APPLICATION NO.	FILING DATE	FIRST NAMED INVENTOR	ATTORNEY DOCKET NO.	CONFIRMATION NO.
10/726,182	12/02/2003	Brian W. Brandner	2681.3184.001 (588/AW)	2575

Office Action Summary

DETAILED ACTION

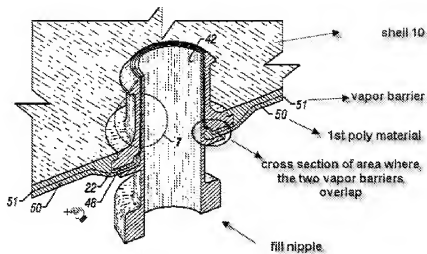
14. In response to applicant's first argument, Potter does not meet the independent claim 23, Please refer to examiner interpretation of Potter below.

The examiners interpretation above clearly shows where in Potter two vapor barriers overlap, layer (51) of the shell being the first layer and also labeled layer (51) of the nipple being the second. In response to applicants comments about page 8 of the office action dated 05/27/2008. The examiner was showing a second interpretation of Potter where the flange 22 also, meets the structure and recitation of "vapor barrier" and

that flange (22) is considered a third vapor barrier layer, thus dually satisfying the claim language of "at least two vapor barrier layers along the entire extent of the overlap of the fill nipple and the shell". Also one can see that this outer layer is of different material by looking at the outer most layer of fig. 7 compared to the inner most material show in fig. 7.

15. In response to applicant's arguments under title Claim 26 and 27, Examiner draws attention to the above interpretation of Potter where the vapor barrier of the shell labeled (51) and the vapor barrier of the nipple (51) are both clearly pointed out. The ellipse callout has been drawn to show the area where the two layers overlap in a separate and spaced relationship.

Fig. 3

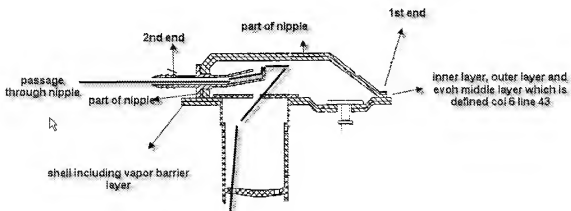
16. In response to applicant's argument under title Claim 9, applicant disagrees with the structure of Van Schafingen's nipple. For clarification examiner views in (fig. 3 as above) the nipple to be from the outer most tip of element 10 until it's connected to the shell, including element 1 having the multi-layer construction layers. The combination would be a embodiment in Van Schafingen's fig 3 with an additional vapor barrier layer (Gerard 109) as taught by Gerard (cover).
